Access Compliance Report Public Rights-of-Way (RR Crossings)

Intersection ID: 7375	Main Street: N_TRYON_ST	Location: N/A
ADA ID: 81B7B7A36DB0	Overall Compliance: No	Severity Score: 0.0
Codes/Mitigation Info/Possible Solution		Field Measurements/Component Compliance

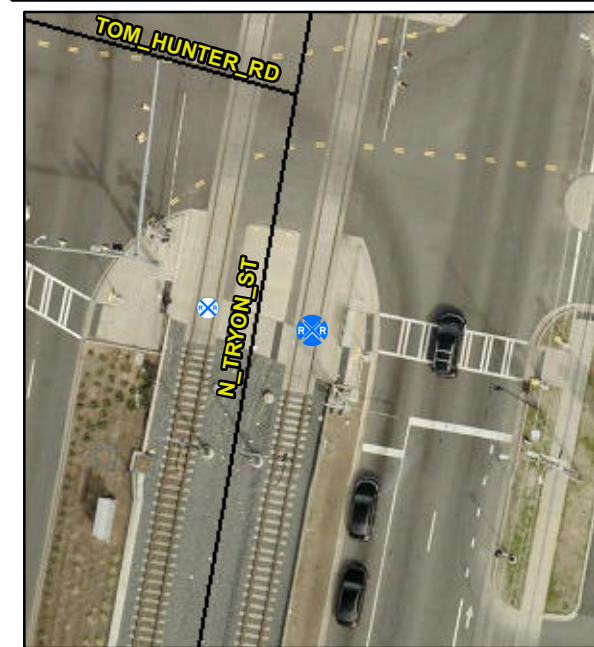
**Remove & Replace Detectable
Warning System. Provide Pedestrian
Gate. Remove & Replace Walking
Surface Adjacent to Rail.**

Compliance	Description	Data
Yes	DWS Provided?	Yes
Yes	DWS Contrast?	Yes
Yes	DWS Width (in)	Yes
Yes	DWS Length (in)	24.0
Yes	DWS Offset (in)	83.0
No	Pedestrian Gate?	No
N/A	DWS Outside Gate?	No
N/A	Rail Type?	LightRail
No	Flangeway Gap (in)	2.625
Yes	Sidewalk Width (in)	119.0
